Interactive comment on “Topographic effects on solar radiation distribution in mountainous watersheds and their influence on reference evapotranspiration estimates at watershed scale” by C. Aguilar et al.

Received and published: 10 June 2010

Fig. 1.

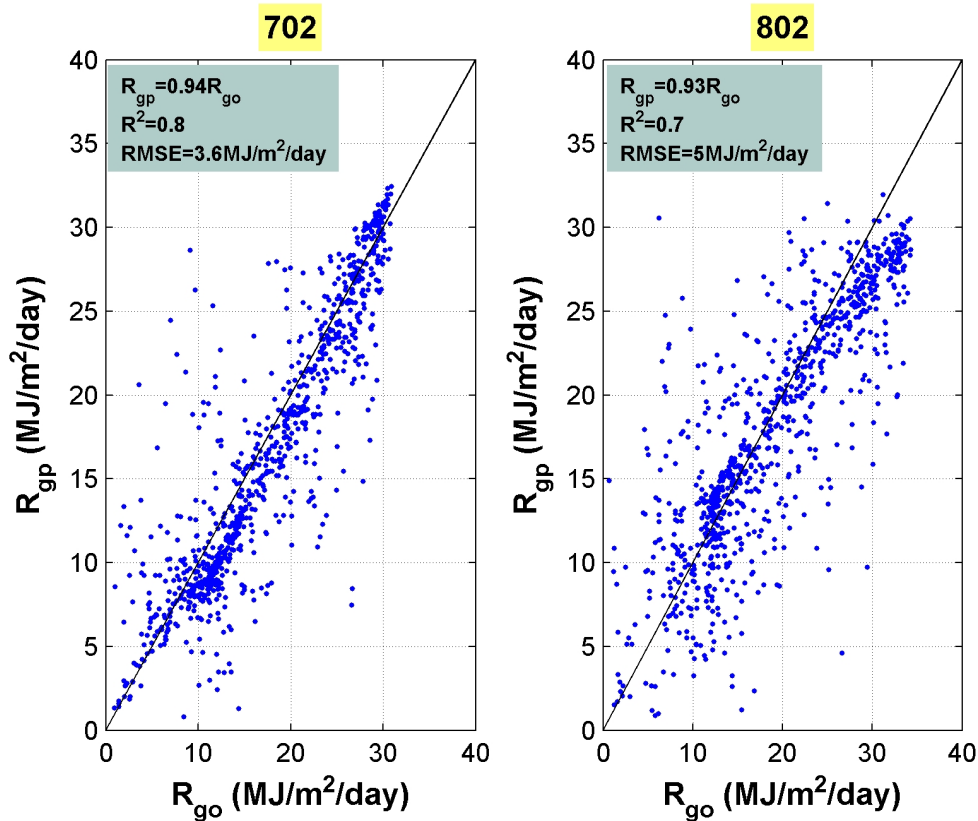
"4. RMSE should be shown in Fig. 5 and 7."

We acknowledge this suggestion. Both values have been incorporated and give more information regarding the degree of adjustment between observed and predicted values by the model at both temporal scales.
